# **APPENDIX 1**

### **PHOTOS 11, 12, 13 and 14**

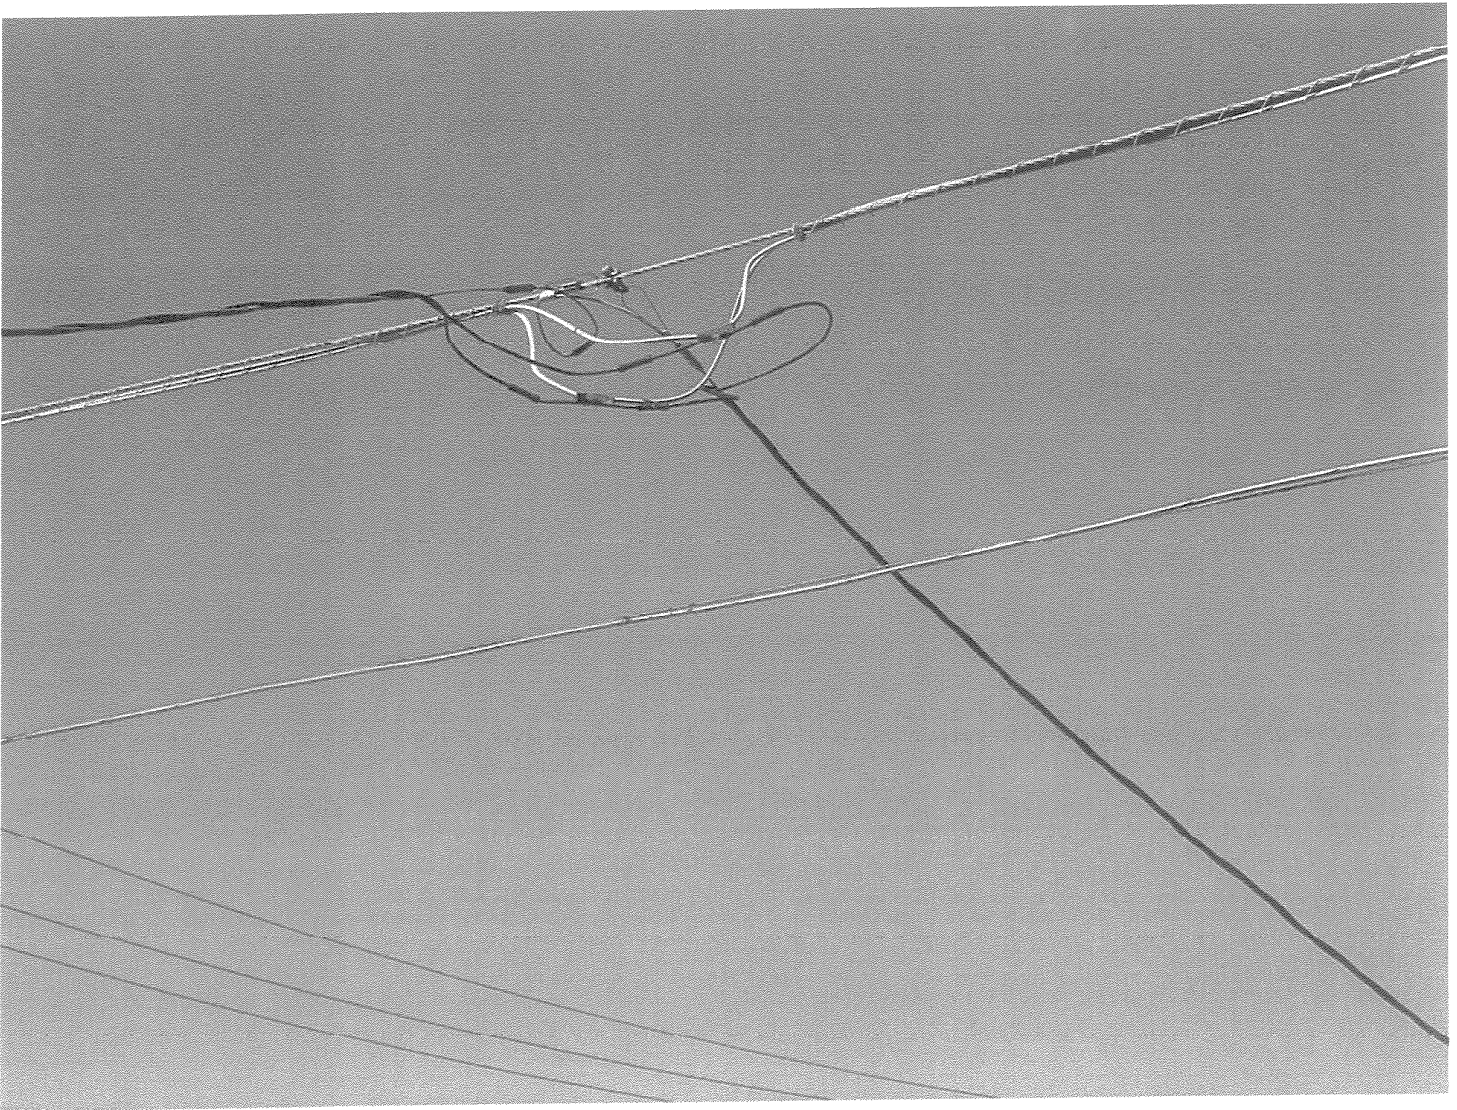
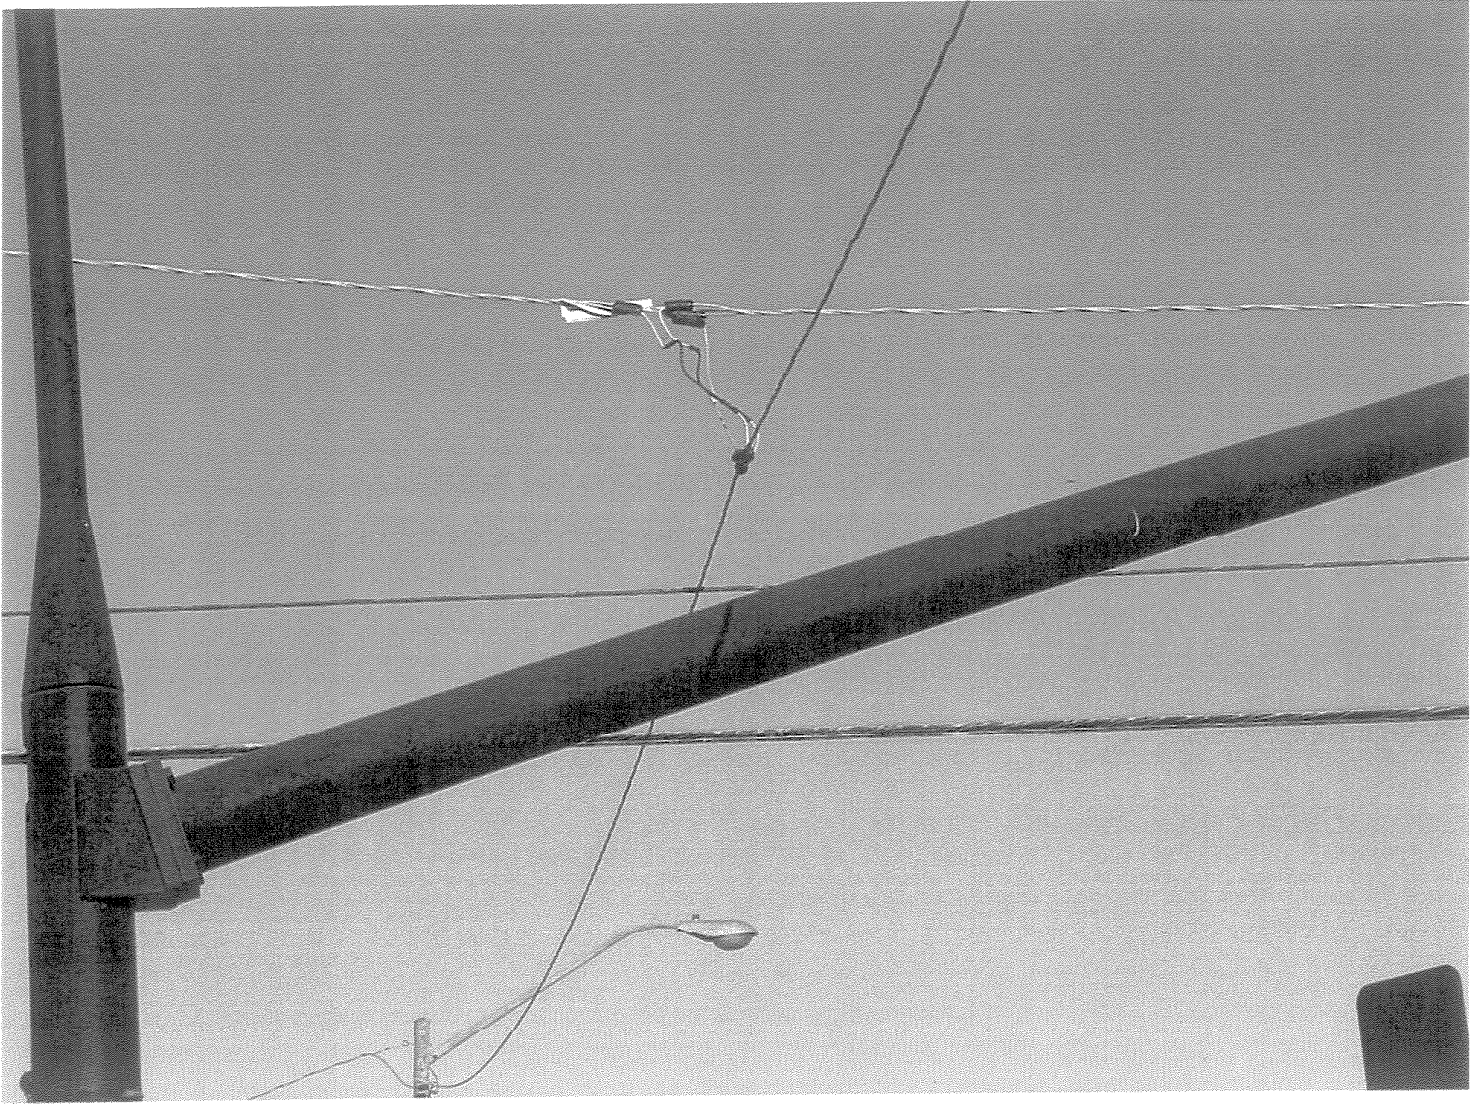
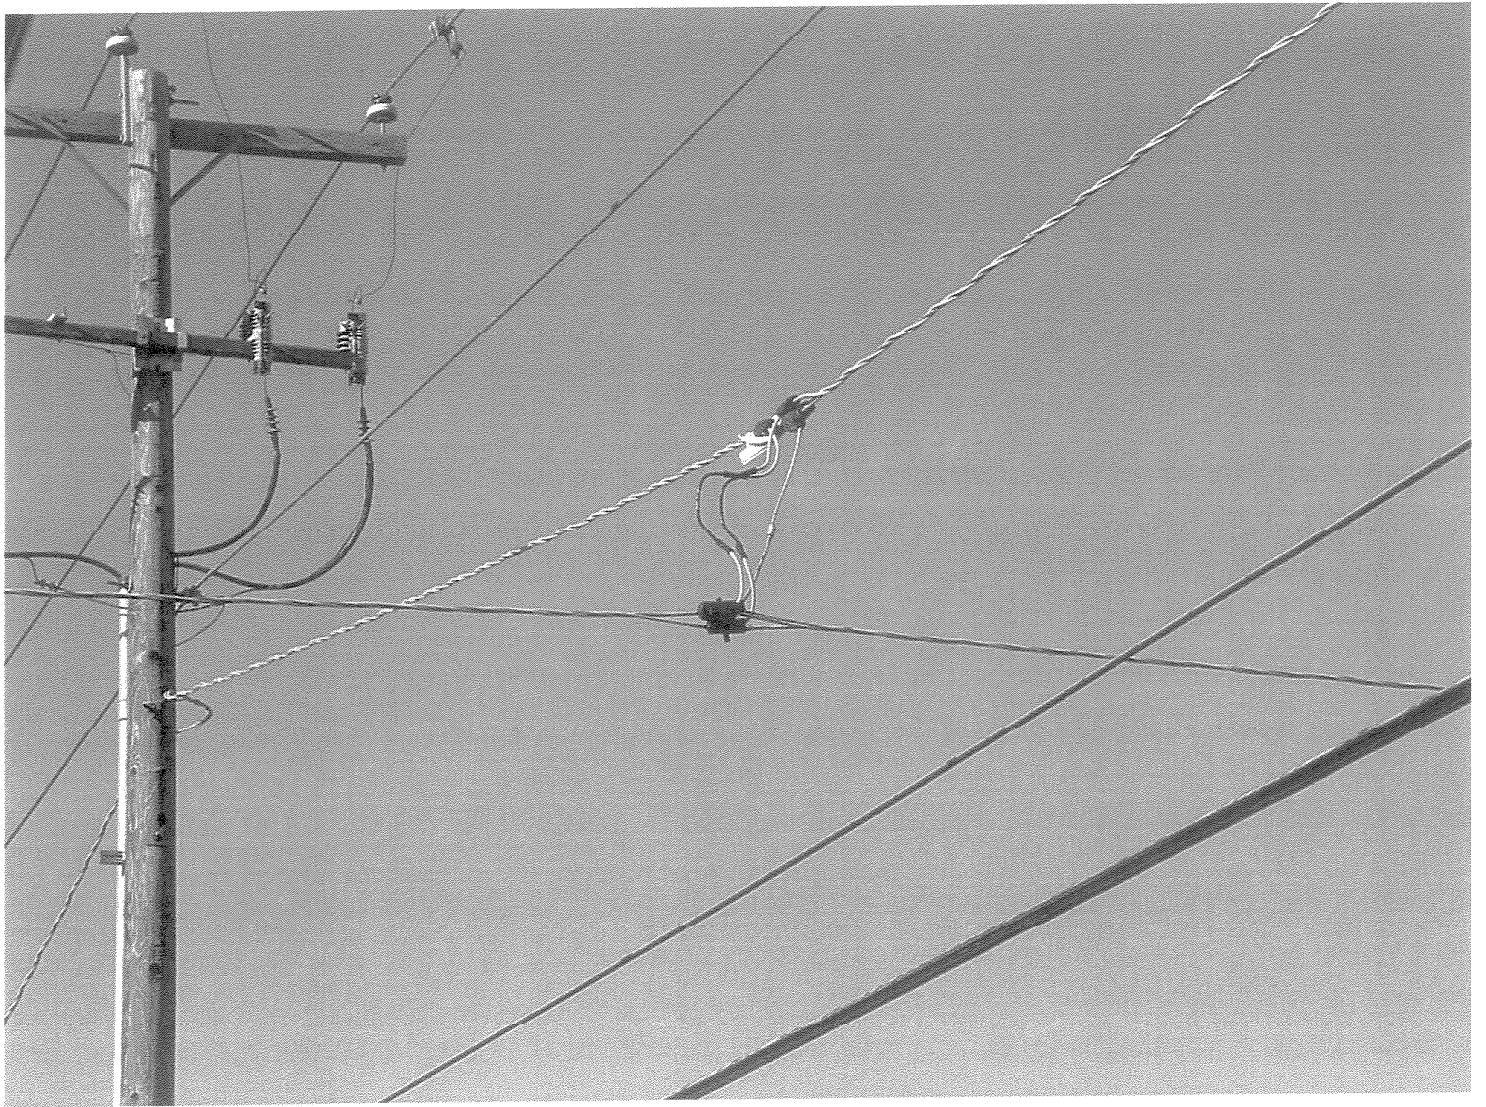
An example of another type of violation that I saw very often appears in photos 11-14. These are good examples of the common PacifiCorp practice of connecting electric service wires in the span between poles. This creates additional weight on the span and forces the secondary cable into violation with cable because the correct NESC clearances are not maintained. This violates NESC Rule 235C2B. A similar violation can be found in the next three photos, 12, 13 and 14, which, while supplying street lights as opposed to customer services drops, create an identical violation of the 30-inch rule.

## PHOTO 15

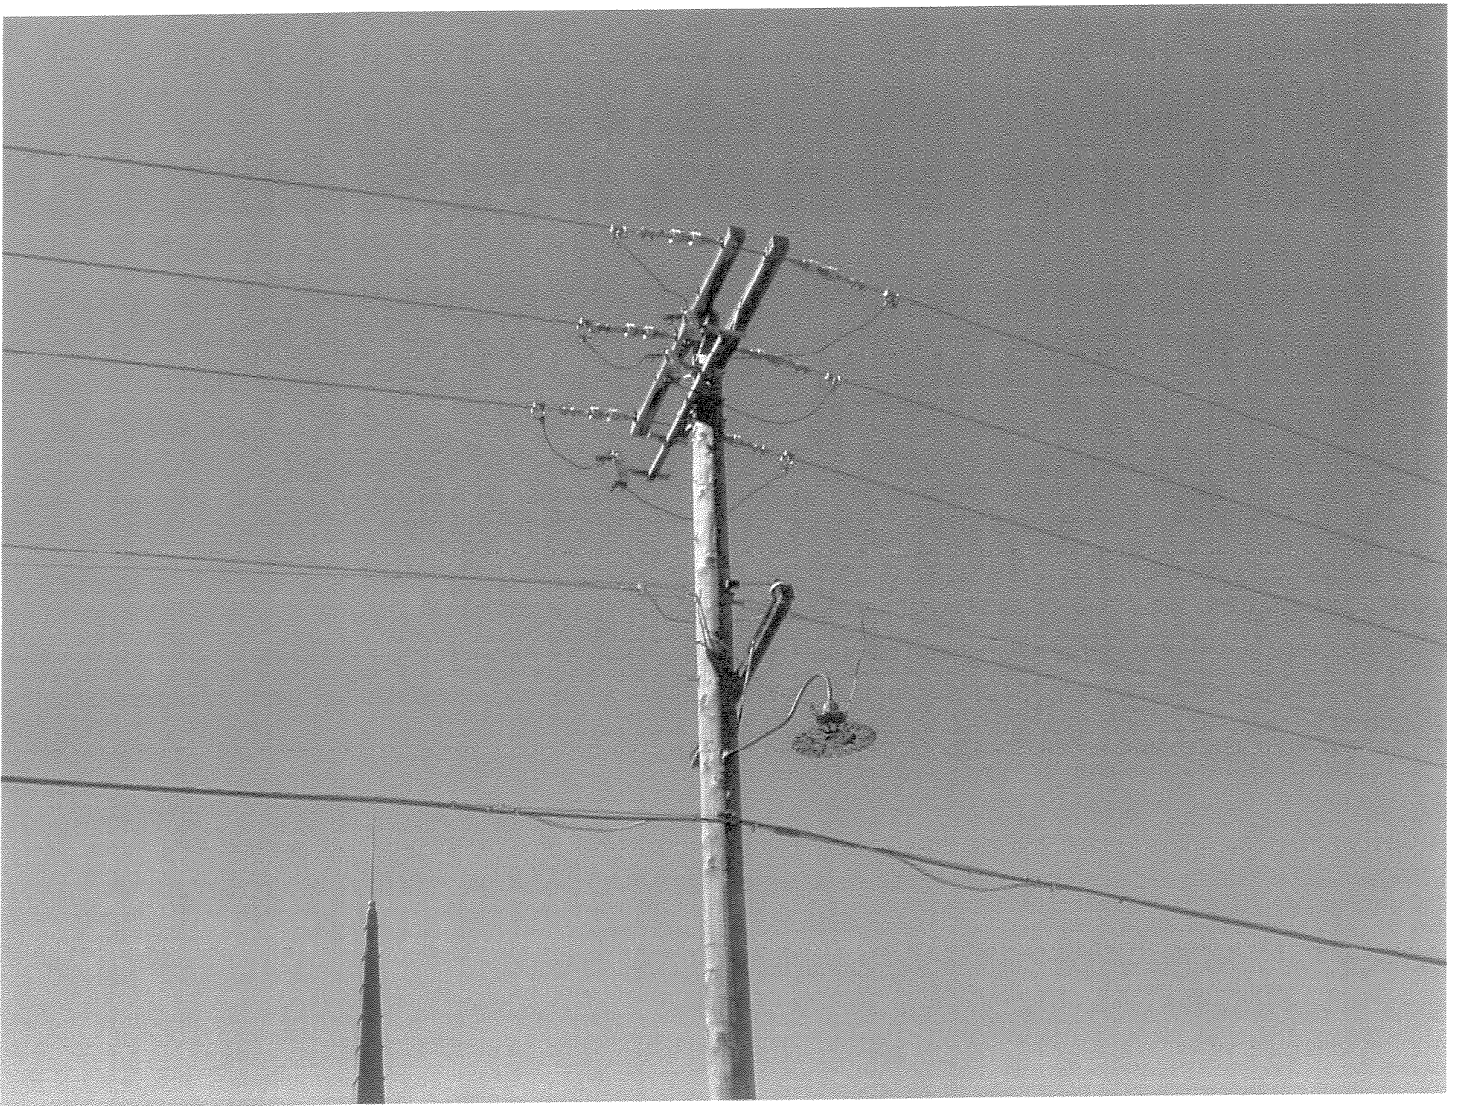
Here you can see a relatively new PacifiCorp pole (I would estimate that it has been in place for only a year or two). While the pole is new, it shows that PacifiCorp has retained an incandescent street light fixture that virtually all power companies phased out between 30 and 50 years ago. I include this because it shows that PacifiCorp is using wiring techniques that are very old. In fact, I would expect that PacifiCorp would be hoping to eliminate this kind of configuration at some point. Notice in this photo how the street light leads go directly from the series circuit down to near the light-bulb socket. This series or arc circuit is on the wood cross arm with the primary voltage conductor on the shorter poles that you will notice in the next (and last) photograph. Its location on the primary arm makes it more hazardous to work on or near.
